May 27, 2022

**RE: Monticello Steam Electric Station – CCR114 – New Registration – Technical NOD #1**

On behalf of Golden Eagle Development, LLC, Gemini Engineering (Gemini) is submitting responses to the deficiencies identified in the CCR Registration Application to the Texas Commission on Environmental Quality for the former Monticello Steam Electric Station (MOSES) facility.

**Deficiency #7 & 8**

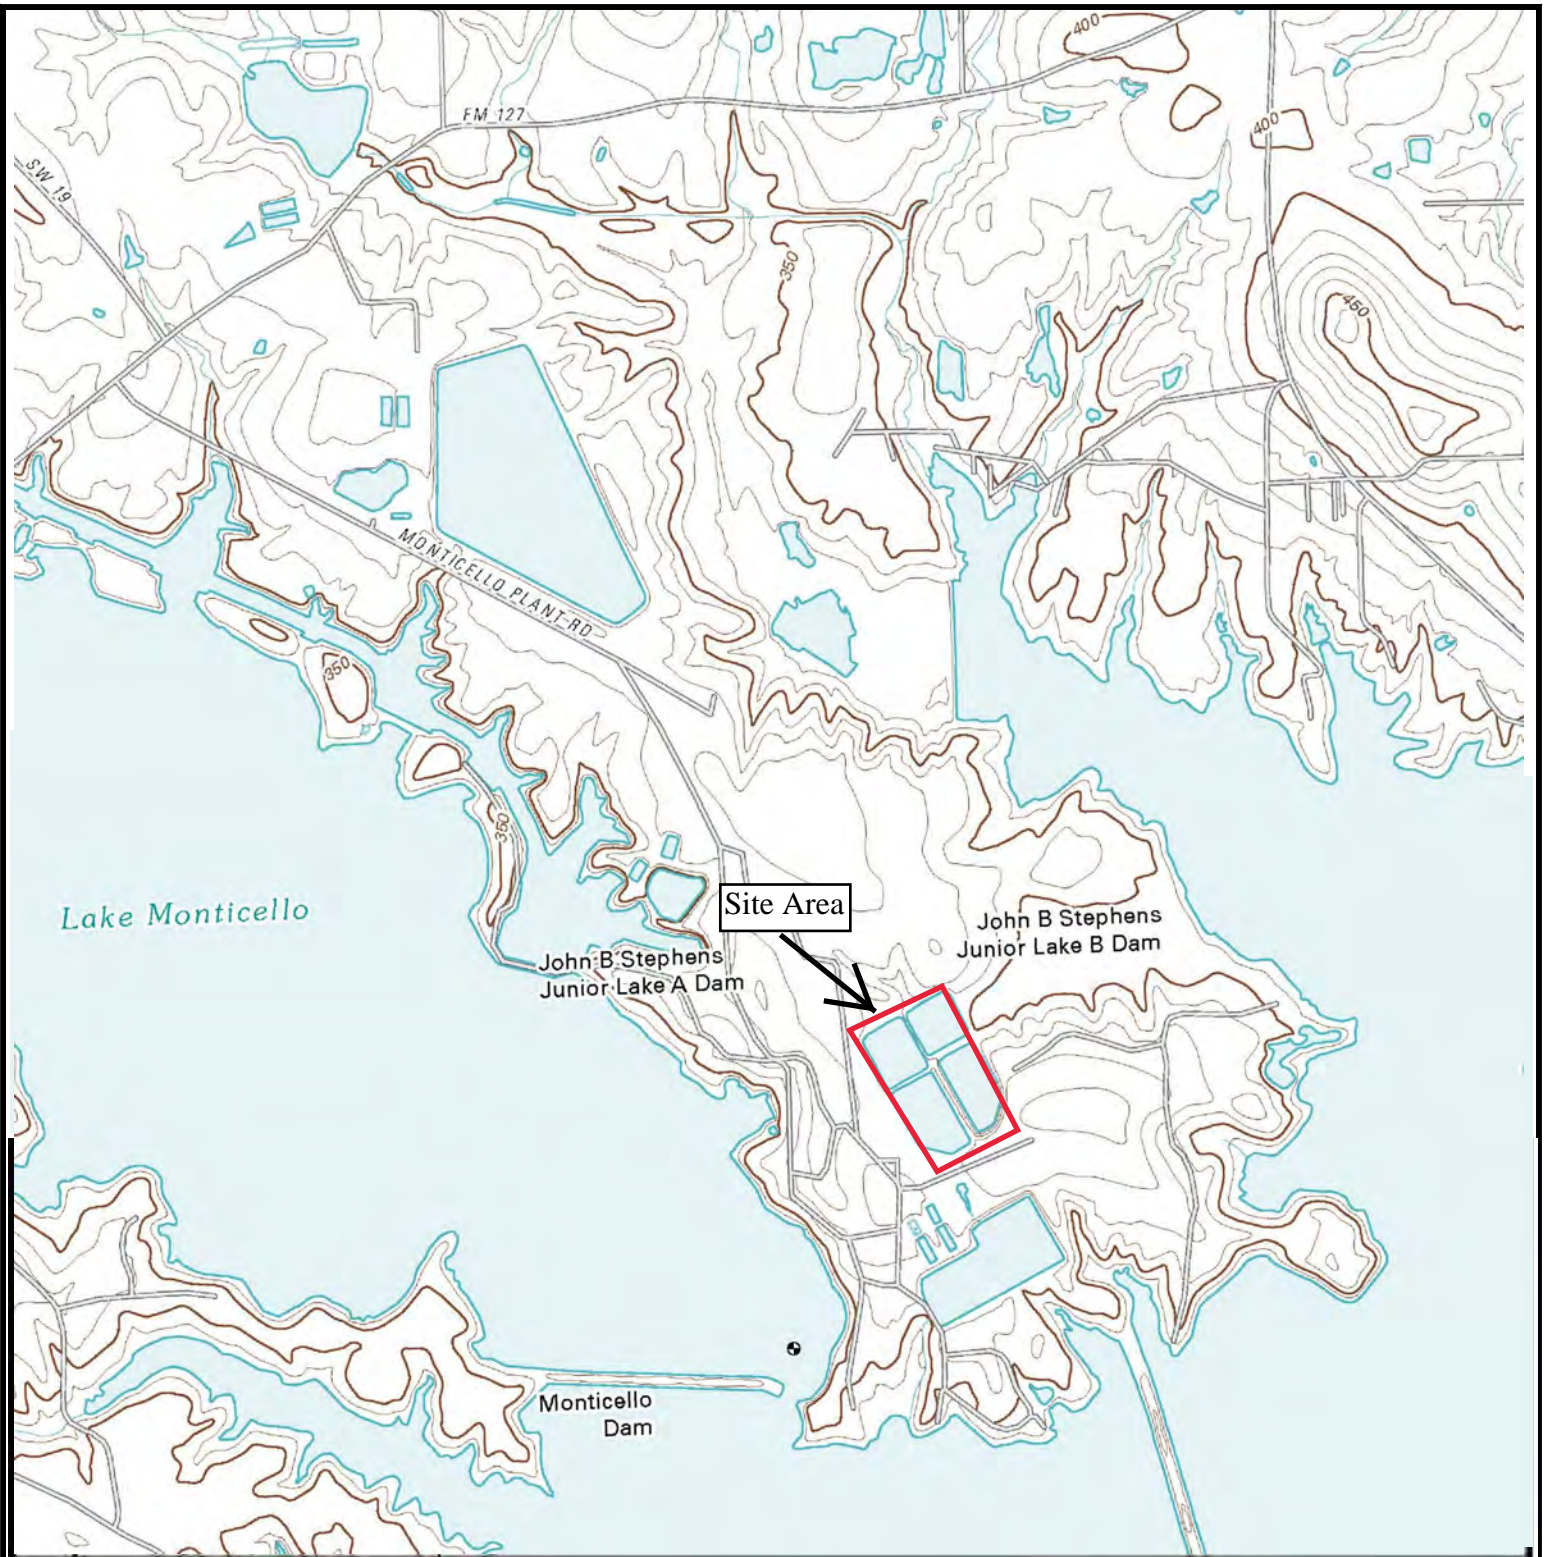
**Deficiency #7:** *Provide a landownership map and landowner list for all property and mineral interest ownership within 1/4 quarter mile of the facility. The 1/4 mile must be from the entire registration boundary.*

**Deficiency #8:** *Provide maps that depict all the attributes listed in each applicable provision/citation and those listed in the instructions on page 6 and 7 of 13.*

**Response:** The landowner maps was provided in the original application. The Titus County Appraisers Office and their mineral rights contractor was contacted, and the mineral rights information is not maintained by the county or easily available. Mineral rights in relation to the surface ownership can be complex and requires a significant amount of research and potential high costs. Additionally, the registration boundary will only include an area around the bottom ash ponds as shown on the revised figures (Revised Attachment 6). The plant was constructed on a peninsula bordered on the south and east by Lake Bob Sandlin and to the west by Lake Monticello, which was the cooling reservoir for the coal-fired power plant. Luminant Generation Company owns Lake Monticello and Lake Bob Sandlin is owned by the Titus County Fresh Water Supply District.

**Response:** The maps and list have been updated. Additionally, the registration boundary will only include an area around the bottom ash ponds as shown on the revised figures (Revised Attachment 6). There is no process flow diagram because the plant is shutdown and the BAPs are not in use; therefore, there are no processes.

**Deficiency #9 - I.21. Verification of Compliance**

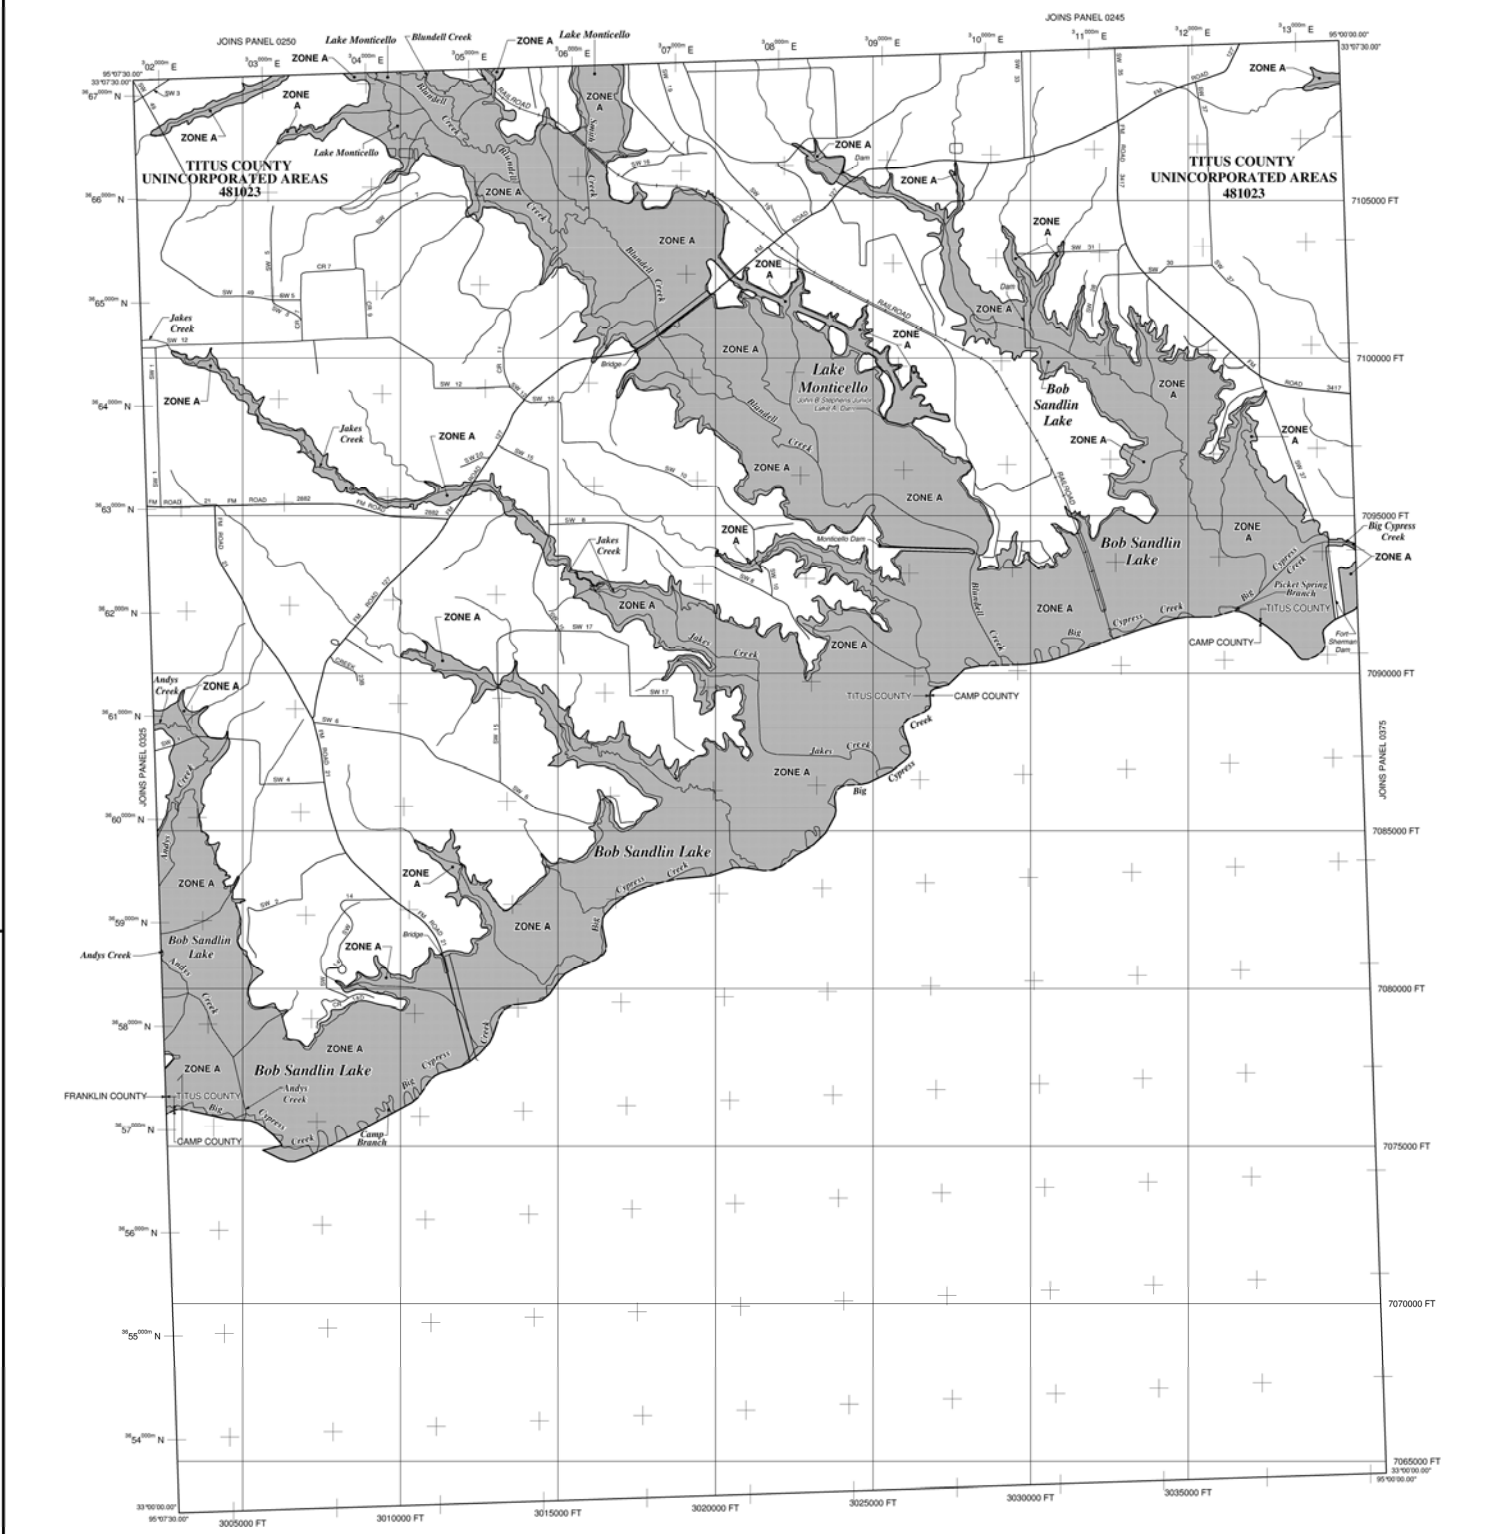
**Deficiency #9:** *Provide documentation to verify compliance with floodplains, endangered species, and surface water protection requirements.*

**Response:** The floodplain, endangered species, and surface water protection requirements may not be relevant since two of the three ponds have the ash removed and the third pond is in the process of removal and expected to be closed by Fall 2022. The ash ponds have been present since the

1980's and the owner is not aware of any previous endangered species studies. Per Federal Emergency Management Agency Maps, the MOSES area has no base flood elevations determined (See the Deficiency #9 attachment).
